Chemical Engineering Branch/Fire Protection Section
Supplemental Safety Evaluation Report
Palo Verde Nuclear Generating Station, Units 1, 2 & 3
Docket Nos. 50-528/529/530

9.5.1 Fire Protection Program

Enclosures: Drawings 5564
5565

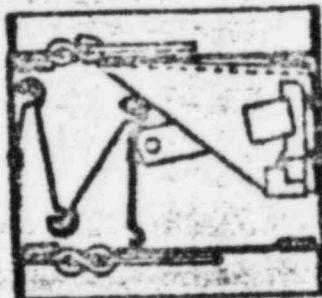
Although it appears that this method should have eliminated the problem, an engineering firm has indicated to us that some of the screws worked loose during shipment. This raises the possibility that the use of screws as a fix is questionable. We therefore request that you stop any activity relative to the installation of this fix.

Ruskin has now developed an alternate fix consisting of a small metal clamp which attaches to the spring bracket and provides a positive stop for the spring (see drawing 5564).

Ruskin has developed a snap-in strip which when installed will hold the bottom blade in the proper orientation and insure complete and consistent closure (see drawing 5565).
